APPLICATION FOR MODIFICATION ASSESSMENT REPORT

Application Number:	Mod2022/0699
----------------------------	--------------

Responsible Officer:	Phil Lane
Land to be developed (Address):	Lot 1 DP 206629, 45 Oxford Falls Road BEACON HILL NSW 2100
Proposed Development:	Modification of Development Consent DA2020/1043 granted for subdivision of land, including alterations and additions to a dwelling house, new driveway and parking
Zoning:	Warringah LEP2011 - Land zoned R2 Low Density Residential
Development Permissible:	Yes
Existing Use Rights:	No
Consent Authority:	Northern Beaches Council
Land and Environment Court Action:	No
Owner:	Jiri Albrecht Marcela Albrecht
Applicant:	Vaughan Patrick Milligan

Figure 1 - Nil setback for planter boxes and 0.8m setback for the OSD.

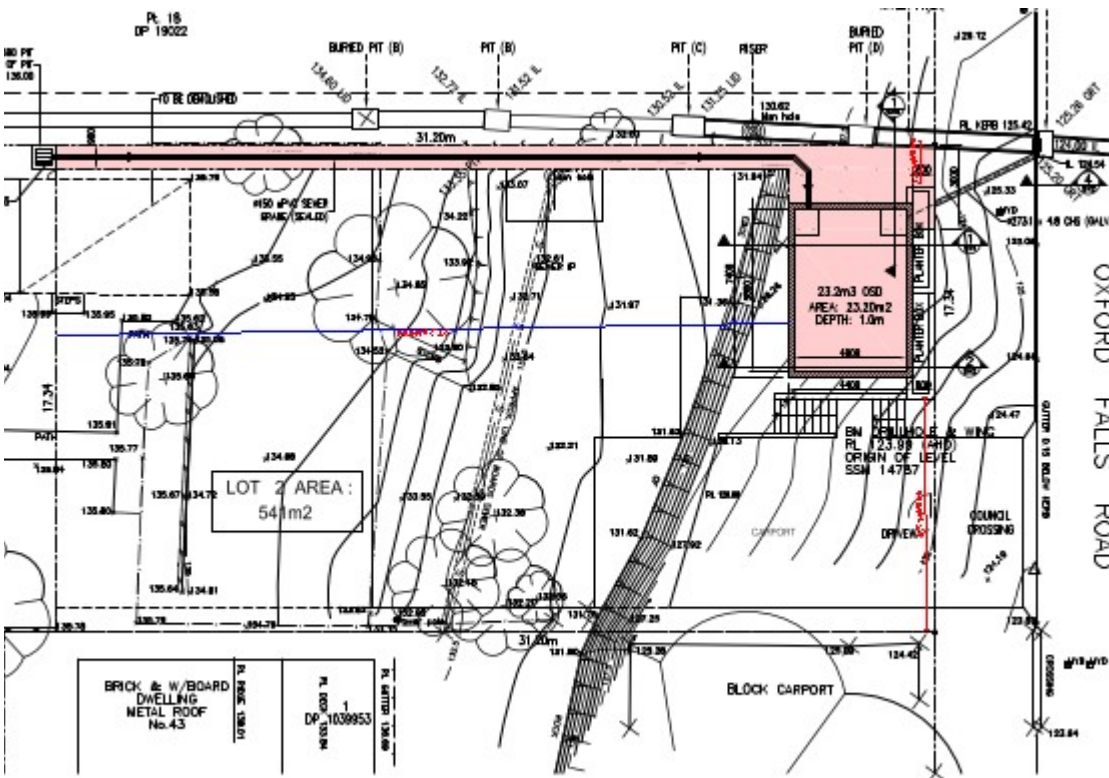
The proposal comprises of a non compliance to the front boundary setback control with a variation of 100% with the proposed planter boxes positioned at Nil setback from the front northern boundary and the OSD located 0.8m from the front northern boundary representing a variation of 87.7% to the control. The relocation of the OSD system will ensure that the stormwater from the site(s) will drain directly to Council's Stormwater Pipeline and Pit located in Oxfords Falls Road which which achieves a better engineering outcome.

The proposed planter boxes and OSD are low structures which demonstrate a sense of openness and it is considered that the encroachments do not create any additional bulk when viewed from the streetscape. The non compliance is considered acceptable within this context.

The proposed development is consistent with the adjoining structures along Oxford Falls Road and Iris Street which has a similar significant slope to the front portion of the site. The existing rock features will remain ensure that the proposal will demonstrate consistency with this merit consideration.

The non compliance is not expected to have any adverse impacts on the surrounding visual amenity as the carport will follow established setback pattern.

Having regard to the above assessment, it is concluded that the proposed development is consistent with the relevant objectives of WDCP and the objectives specified in S1.3 of the Environmental Planning and Assessment Act, 1979. Accordingly, this assessment finds that the proposal is supported, in this particular circumstance.
